ANN ARBOR HISTORIC DISTRICT COMMISSION

Staff Report

ADDRESS: 116 South Main Street, Application Number HDC17-068

APPLICATION: The applicant seeks HDC approval to replace a non-original storefront and second floor with a new storefront and second floor in a new design that is compatible with the building and surrounding historic district.

Proposed East Elevation

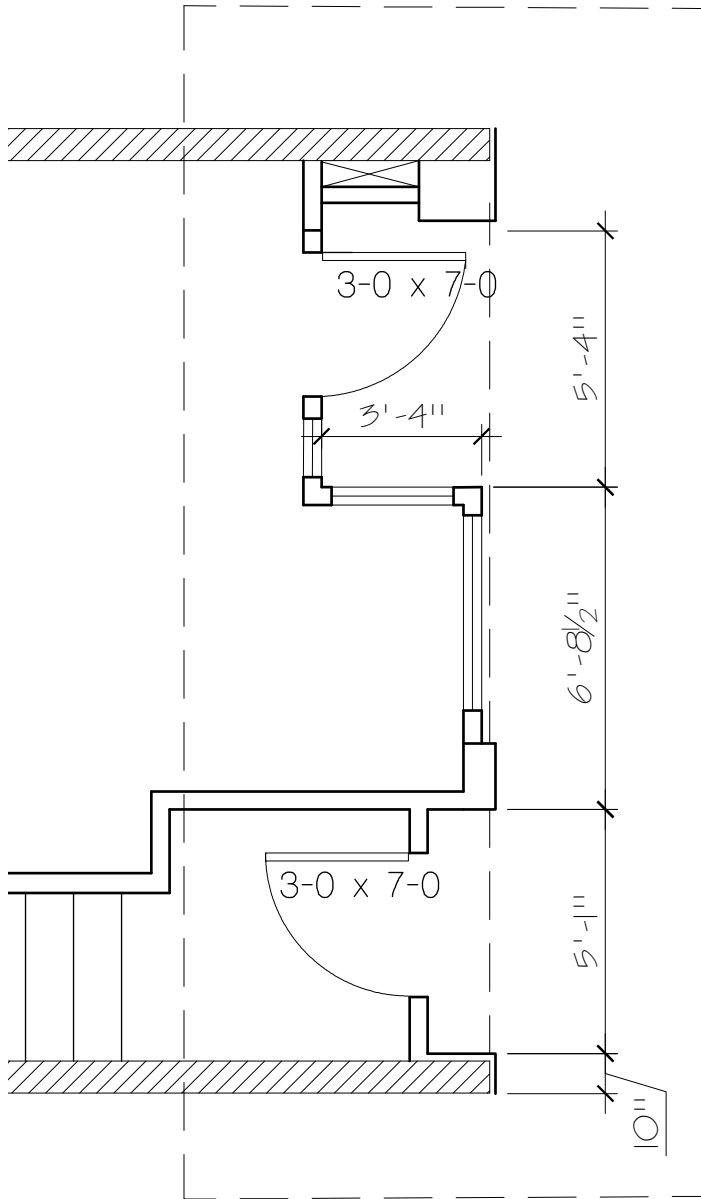
1. Have you determined that stripping the paint from the historic brick up top isn't feasible or will be too destructive?

2. You had mentioned a masonry or tile storefront base/kickplate, now changed to wood. Any reason?

3. Is the door wood?

4. Will the wood/MDO storefront be painted? Or stained? I'd strongly suggest

bringing a sample of MDO to the meeting, to alleviate fears that it may look vinyl clad instead of resin-infused.

5. The storefront proportions look great! thanks for giving that your attention.

We have not officially attempted to remove the paint. A concern of course will be can we remove all the paint and what is the safest/least destructive means to removing the old paint.

The bigger concern is if we are successful at cleaning up the old paint can we match the brick/mortar. Painting is the logical step but until we 'peel back the skin the onion' and assess the condition we will commitment to painting.

We will placing at least a 4" tall limestone 'sill' piece along the entire bottom of the facade at sidewalk grade. Primarily to reduce/eliminate 'sodium' intrusion onto the wood. Now that we are looking at an all wood store front at the first floor using a taller 'masonry tile' look was removed. I'm certainly receptive to something taller. Perhaps the Commission will work with us as we proceed in the construction.

Yes. Wood and glass. Since we picked up on your comment about the early 20th century store front, we might opt to use a 6' 8" door instead of a 7' tall door as we do not want to squeeze the glass tile band. I need not tell you on paper its one thing but some how some way it takes on a whole different look in the field. The 4" of limestone is causing us bit of a head twist as we are somewhat locked in on height since we have an existing large steel beam at (bottom side of beam) 10' 11" off the sidewalk.

I'll make sure to bring in a sample. Ours will be smooth. No texture on my watch.
